Title Manipulator Gripper			Number <Doc>
Size C	Engineer Scott Jensen	Layout <Layout Eng.>	Filename Sleepy
Date: Thursday, April 14, 2011			Rev 0.0.0
Sheet 1 of 1

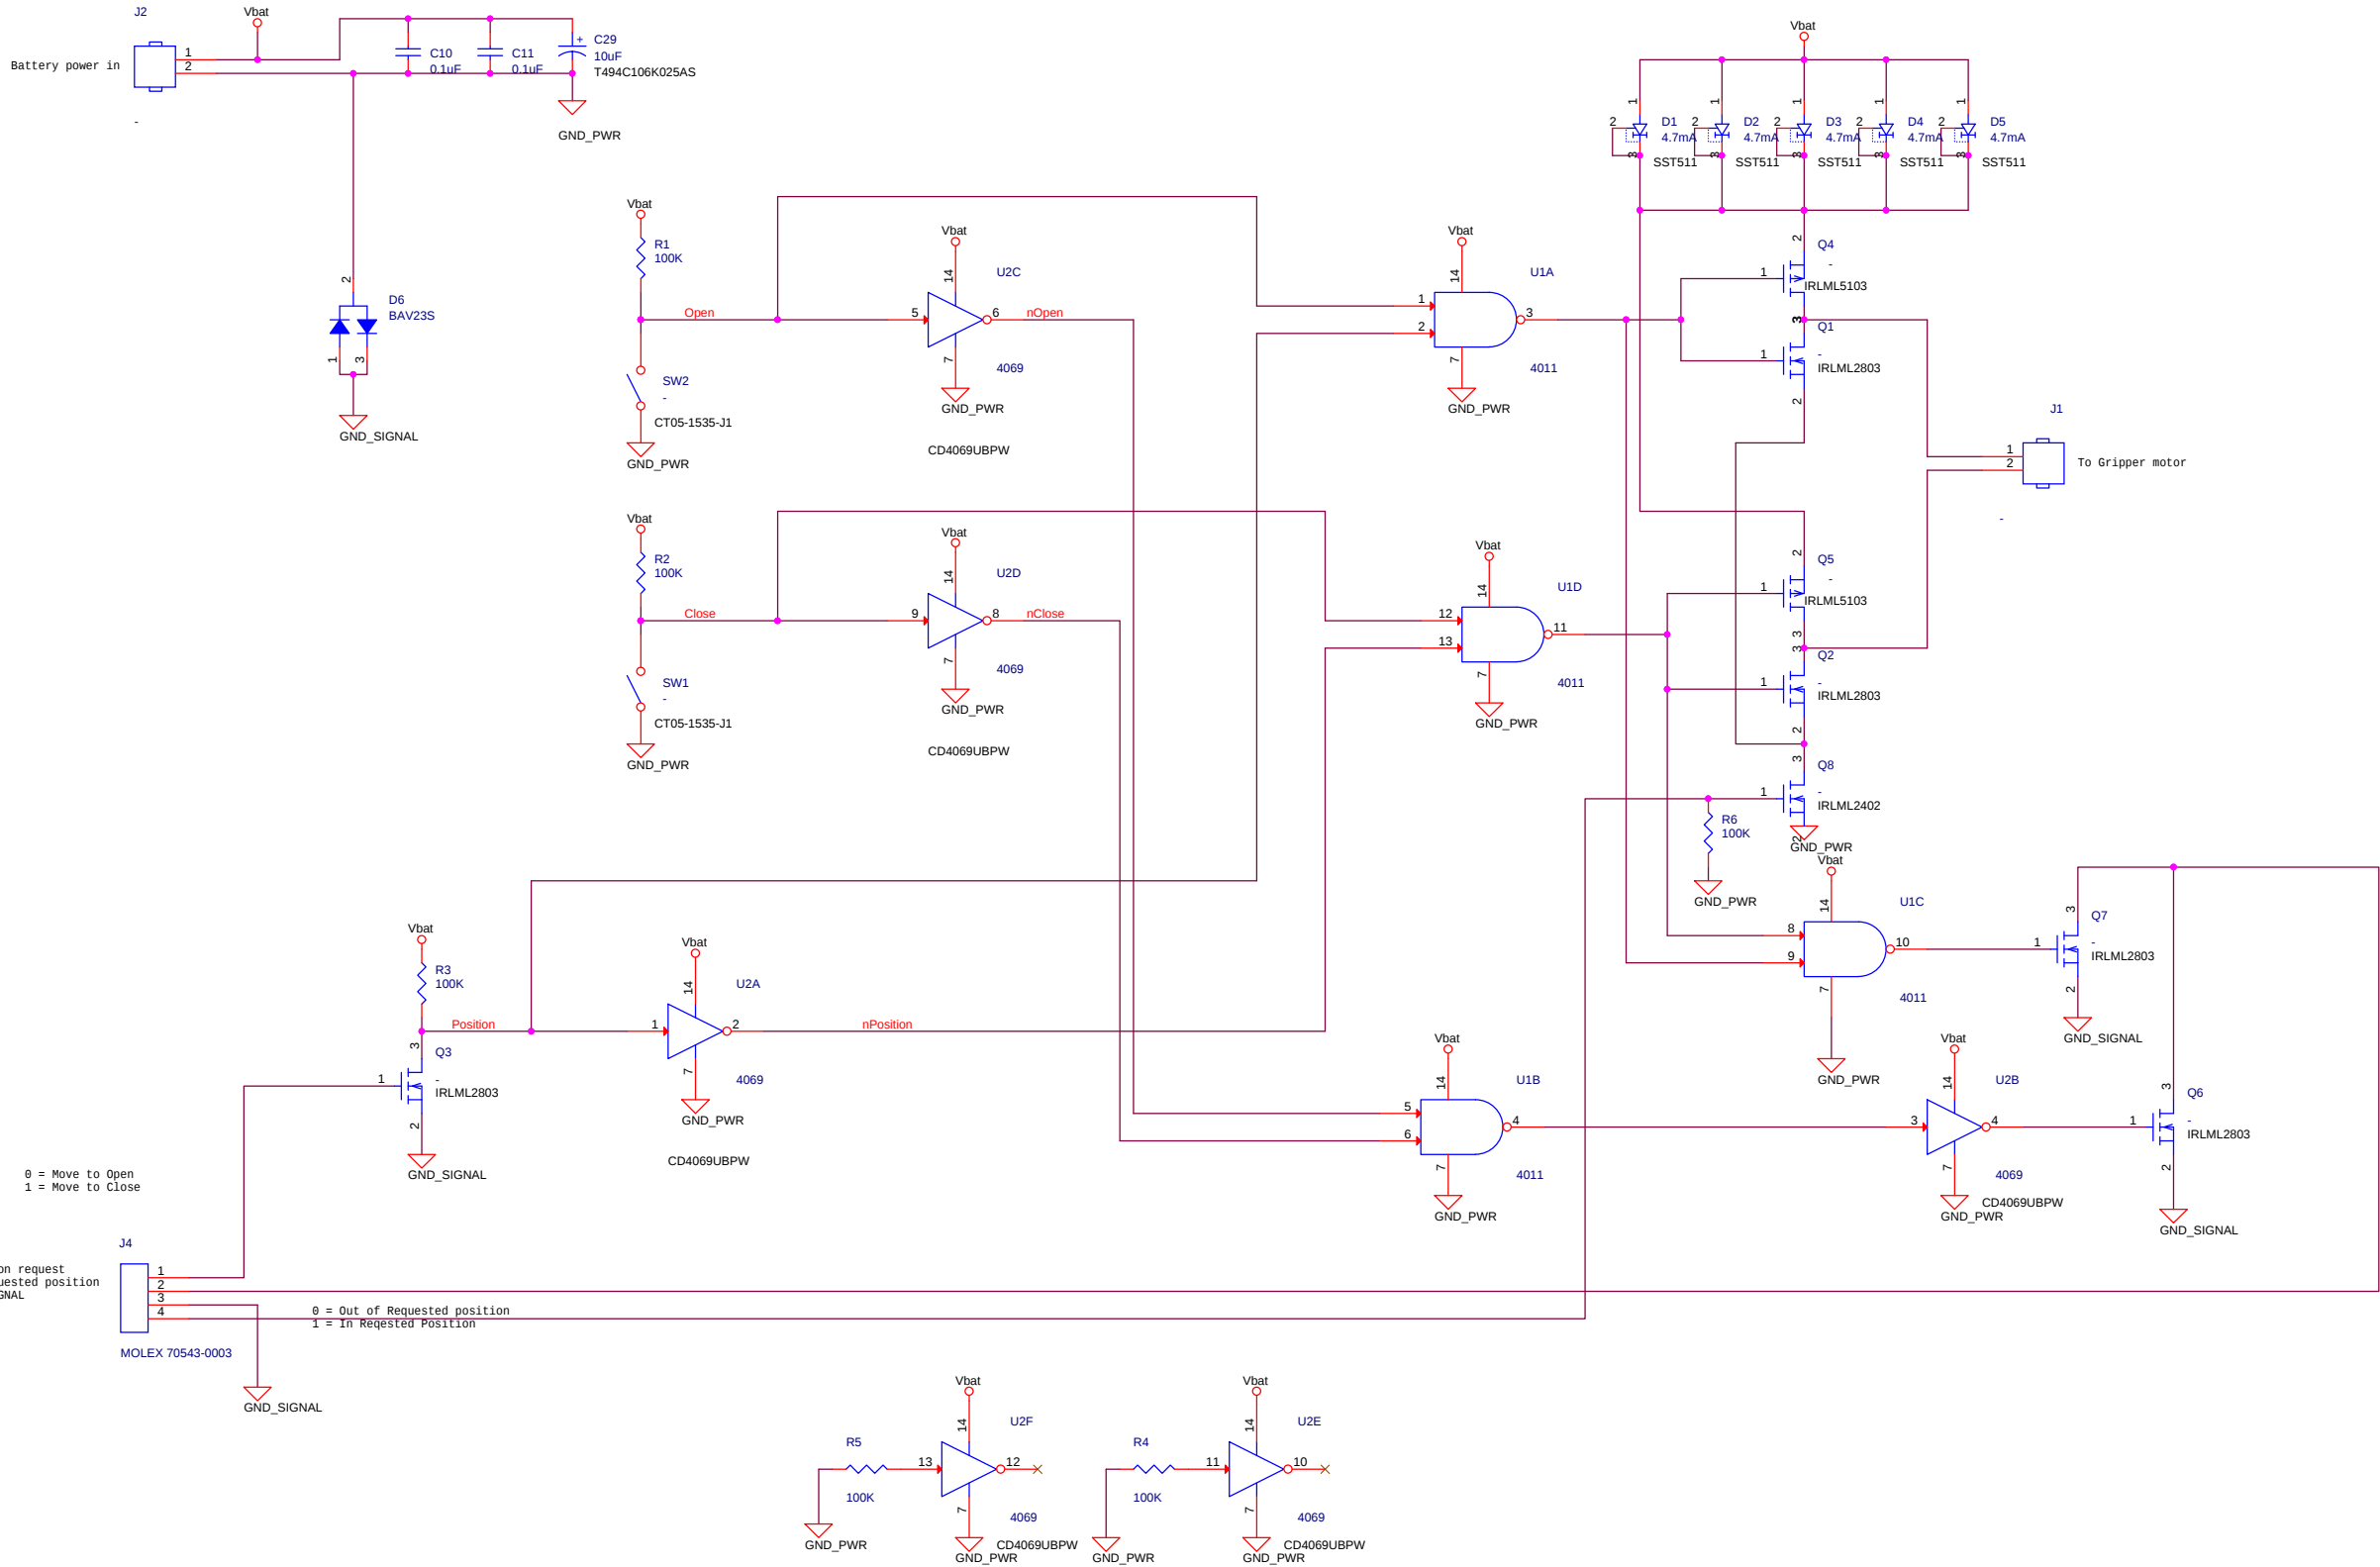
These are extra gates and should have their inputs tied to ground to prevent noise and excessive current draw.
